Access Compliance Report

Public Rights-of-Way (Curb Ramps)

Intersection ID: 12605	Main Street: KENSINGTON_DR	Cross Street: THE_PLAZA	Location: SE
ADA ID: 96D3E5551D28	Ramp Type: Directional1	Initial Pass/Fail: Pass	Overall Compliance: No
Codes/Mitigation Info/Possible Solution			Severity Score: 10
			Field Measurements/Component Compliance

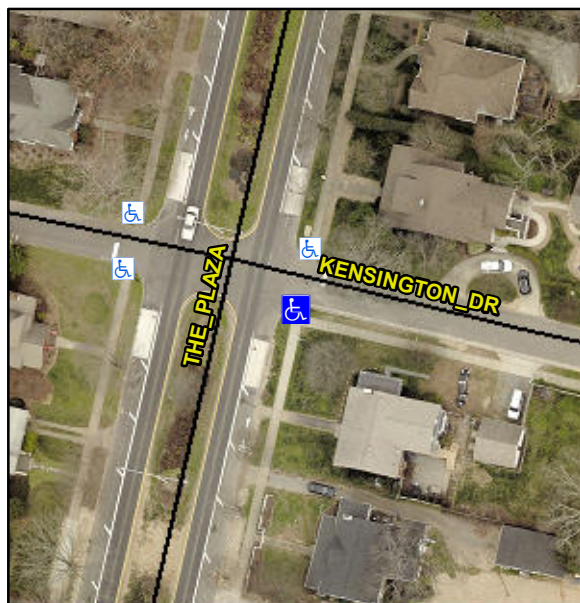
**Not Found, R304.5.3, R305.1.4,
R305.2, R302.7.2**

Compliance	Description	Data	Compliance	Description	Data
N/A	Ramp Length (in)	99.0	Yes	Grade Break?	Yes
Yes	Ramp Width (in)	63.0	No	Grade Break Slope (%)	5.5
Yes	Ramp Slope (%)	5.2	Yes	Grade Break XSlope (%)	1.4
Yes	Ramp XSlope (%)	0.4			
Yes	Flare Type LT	N/A	Yes	Flare Type RT	N/A
N/A	Flare Slope LT (%)	N/A	N/A	Flare Slope RT (%)	N/A
N/A	Flare Traversable LT?	No	N/A	Flare Traversable RT?	No
Yes	Landing Length (in)	61.0	Yes	DWS Provided?	Yes
Yes	Landing Width (in)	65.0	Yes	DWS Contrast?	Yes
Yes	Landing Slope (%)	0.3	Yes	DWS Length (in)	24.5
Yes	Landing X Slope (%)	1.9	No	DWS Full Width?	No
N/A	Landing Curb? (Y/N)	N/A	Yes	DWS Offset LT (in)	13.0
N/A	Shared Landing?	No	No	DWS Offset RT (in)	4.0
Yes	Gutter Ponding?	No	Yes	Gutter Slope (%)	2.1
No	Gutter Lip Ht (in)	0.3	No	Gutter X Slope (%)	3.1
N/A	Painted X Walk1?	No		Road Slope (%)	5.7
	X Walk 1 Direction	To N		Road X Slope (%)	4.6
	X Walk 1 Width (in)	N/A		Clear Space?	Yes

X Walk 1 Slope (%)	5.7	N/A	Clear Space to XWalk (in)	N/A
	X Walk 1 X Slope (%)	4.6	Yes	Storm Grate/Utility Hazard?	No
N/A	Ramp inside XWalk1?	N/A		Storm Grate/Utility Type	
Yes	Any Obstructions?	No			N/A
	Obstruction Type		Yes	Surface Condition? (G/P)	Good
			N/A	Curb Slope (%)	18.0

**Remove & Replace Entire Ramp.
Remove & Replace Gutter.**
